TEXAS UTILITIES GENERATING COMPANY

(Comanche Peak Containment Sump  
Performance Meeting)

UNITED STATES OF AMERICA  
NUCLEAR REGULATORY COMMISSION  
MEETING WITH ADVISORY PANEL ON  
COMANCHE PEAK CONTAINMENT SUMP

July 27, 1984

EQUATION DERIVED BY CHANG LI (NRC)

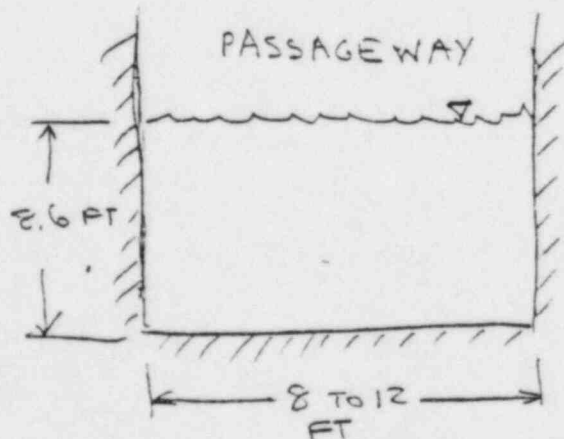
7 MR. LI: In the beginning I asked the question  
8 about L over A versus L over B hydraulic parameters,  
9 summation of how the resistance was upheld. Because  
10 your force field was determined by your resistance  
11 term, in the tables listed, the resistance term was  
12 actually in the context, such as L over Area, pro area.  
13 If you go back to derive equations, L over hydraulic  
14 diameter. So, I just wondered how you...

1 study sensitivity, it doesn't answer my question under  
2 proresistance terms. You have, I don't have the  
3 parameters there. I couldn't assess how much difference  
4 does...Let me derive a question. I read that the actual  
5 terms, the terms that are proresistance or ...either in  
6 terms of mass flow rate or volume, you used in table  
7 substantially this...your table was related to a match  
8 in volume. Okay. Hydraulic Resistance. This is where my  
9 question is. It is not  $L$  over  $A$ . It is a hydraulic...it  
10 is also related to  $L$  over  $A$ .

14 MR. LI: I just wanted to know what the  
15 range...That explains my question that maximum  
16 difference of 17%.

DISCUSSION ON HYDRAULIC DIAMETER VS AREA.

$$\frac{29.2}{25.2} \cong 1.17$$

FIGURE 2

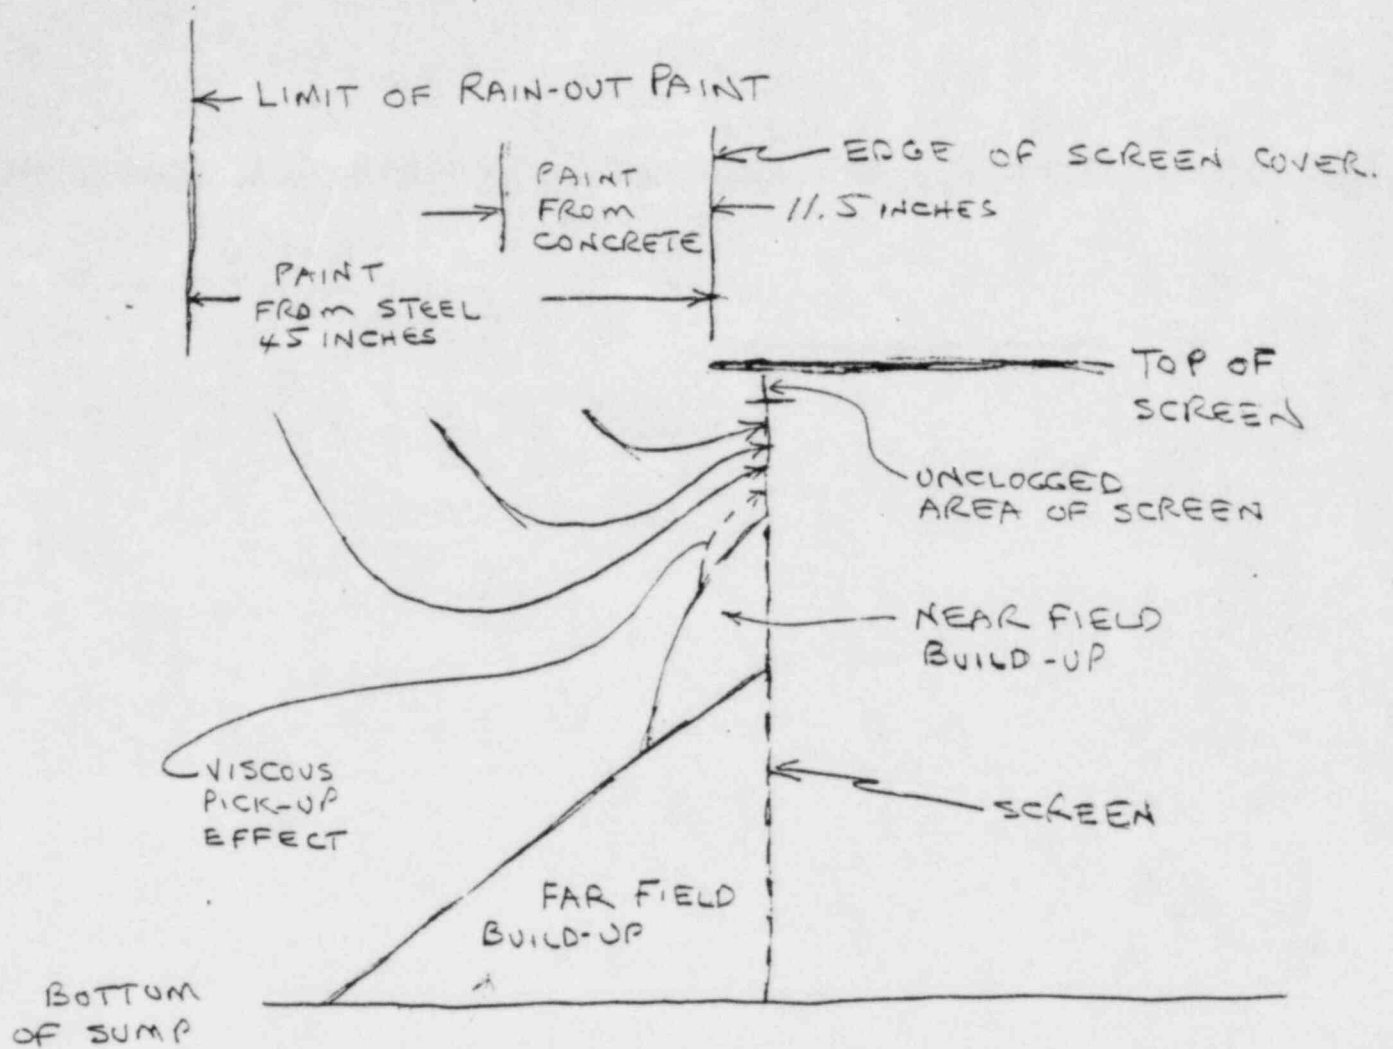
DISCUSSION BETWEEN SERKIZ AND IOTTI  
ON SCREEN BLOCKAGE

FINITE DIFFERENCE ANALYSIS SHOWS THIS BUILD-UP (FROM FLOOR TRANSPORT) WOULD NOT OCCUR.

FIGURE 1

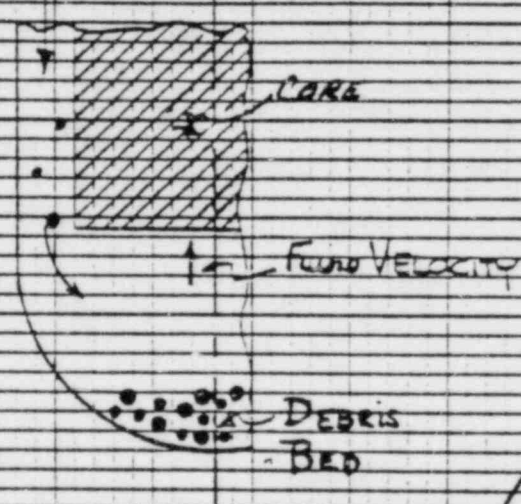
6 I don't care if it's laminar or not. I'm  
7 basing it on Reynolds Numbers --. Now, the calculations  
8 that I've performed to determine particle size as a  
9 -- to the fluid velocity on Figure 1, so that covers  
10 the Point 1 to Point 3 heat perceptive core velocities  
11 that I spoke of earlier. And that describes what's  
12 happening, what's going on.

18 MR. ANDREYCHER: You can use Figure 1 and  
19 the text -- to see how that might run. We'll show  
20 you a half a foot a second velocity. You could  
21 support a particle size something on the order of  
22 around .075 mils, maybe a little larger than that.

Using the preceding assumptions and performing a force balance that accounts for drag, gravity, and hydrostatic forces, a relationship identifying the maximum debris particle size that can be carried by a vertically flowing fluid with a given velocity was developed. A plot of that relationship is given in Figure 1.

Thus for two RHR pumps operating, the fluid velocity in the RV/core barrel annulus is sufficient to reentrain debris that may cause core blockage if it is reintroduced to the RV. From Figure 1, it is concluded that if the fluid velocity in the lower plenum is less than 0.33 ft/sec, only debris that is less than 0.040 inches in size may be entrained. Typically, the fluid velocity in the lower plenum is a maximum where the fluid turns to flow up the downcomer. Figure 3 shows the relationship between vessel flow rate, debris bed height, and fluid velocity as it turns into the downcomer from the lower plenum. From Figure 3, the velocity of the turning fluid is predicted to be below 0.30 ft/sec for debris beds less than 4.7 feet in height. From Figure 4, which is a plot of vessel volume versus vessel height, the debris bed

FIGURE 3

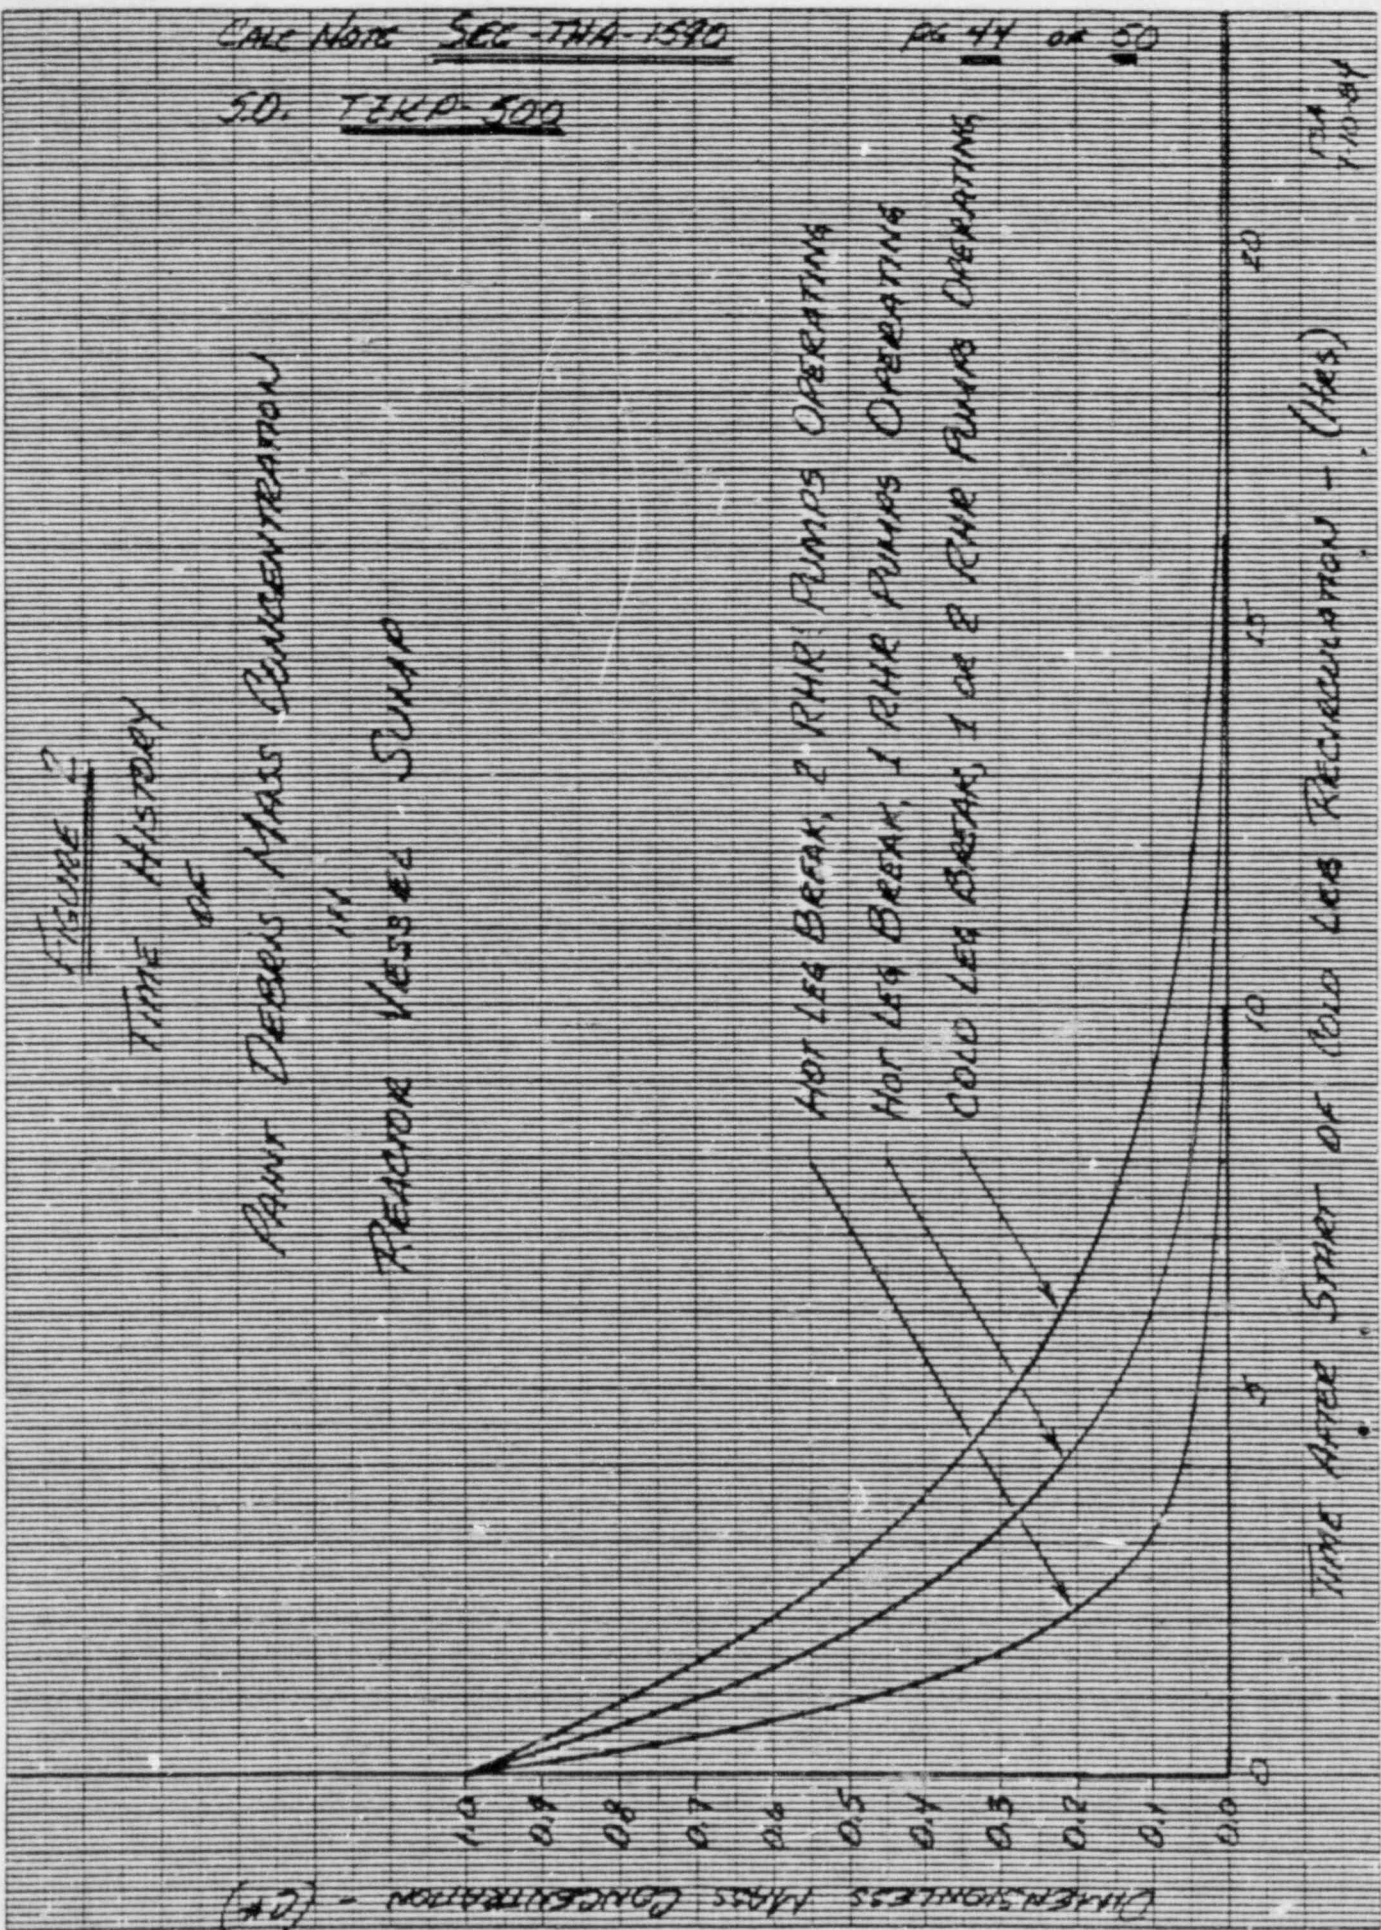
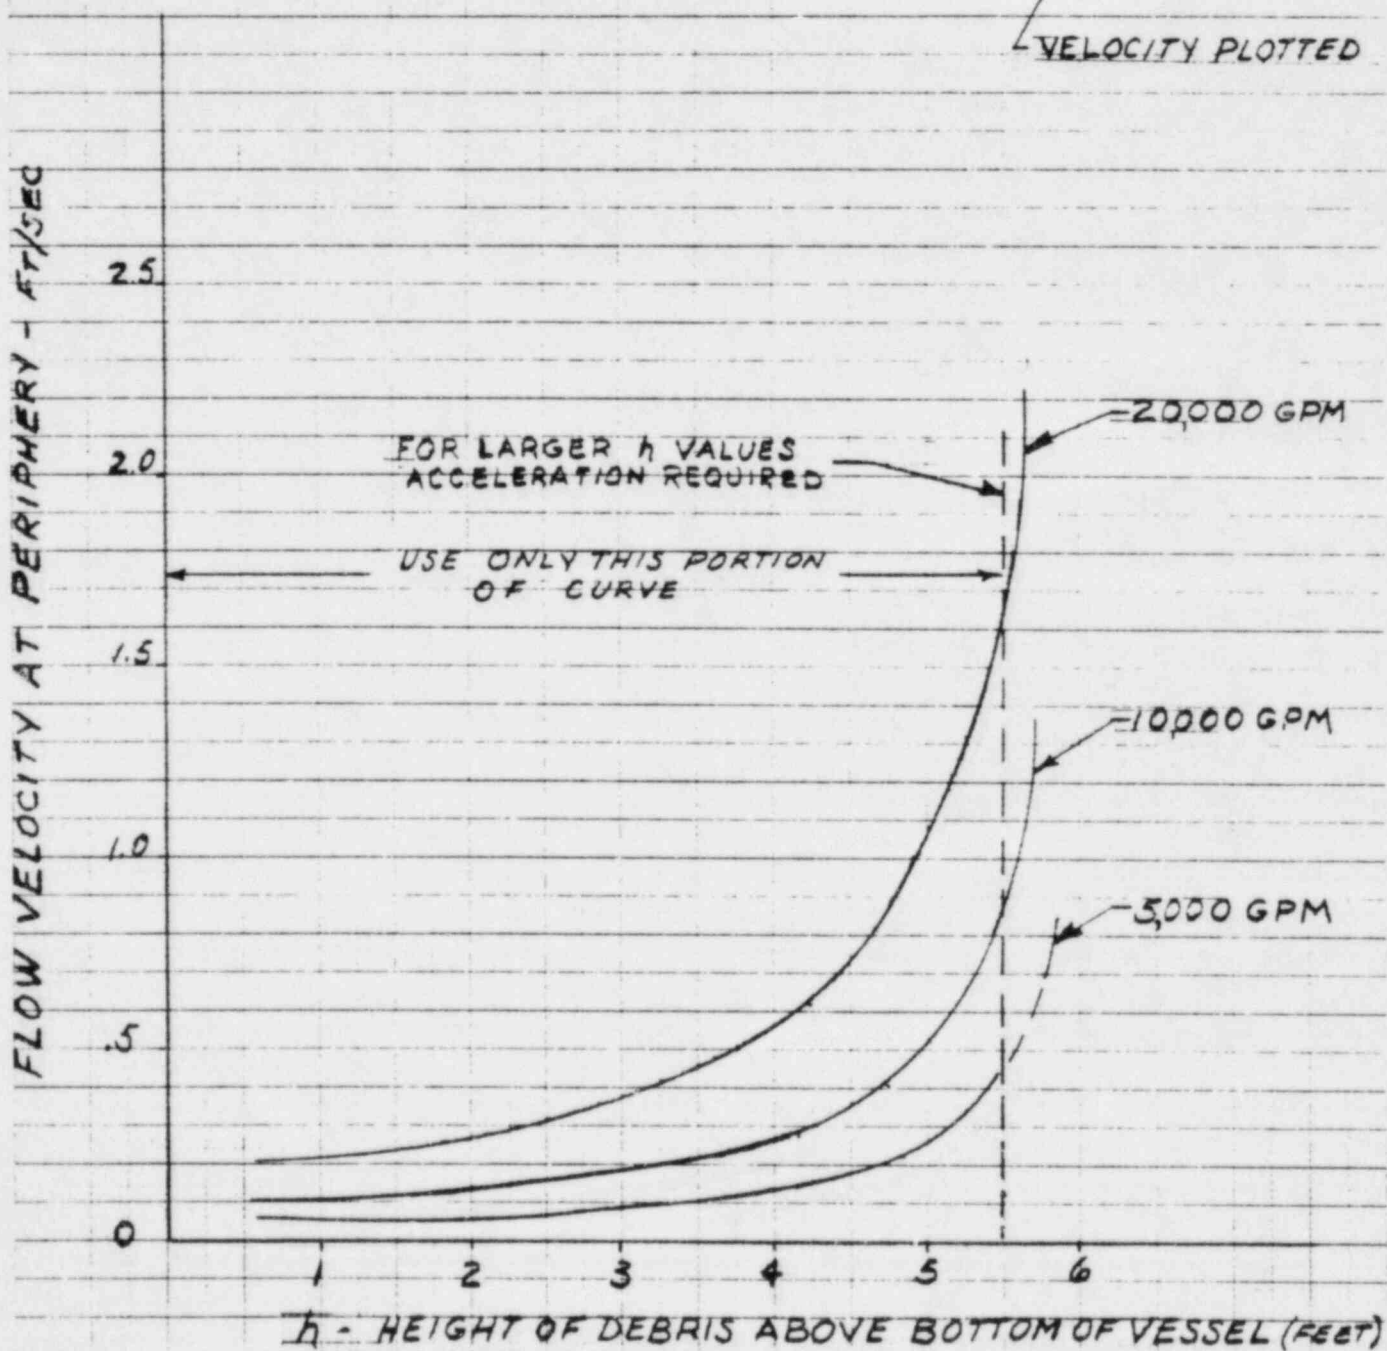
Figure 2 is the time history of debris clean out. Figure 3 -- Figures 3 and 4 are those figures that I used to assess the maximum height of debris that we would have -- we could handle in the lower plenum of the core before we run the risk of the potential of re-intraining.

Now, the flow rates that are listed on the right-hand side of Figure 3, the RHR flow pump is 7800 rpm for 2 RHR --.
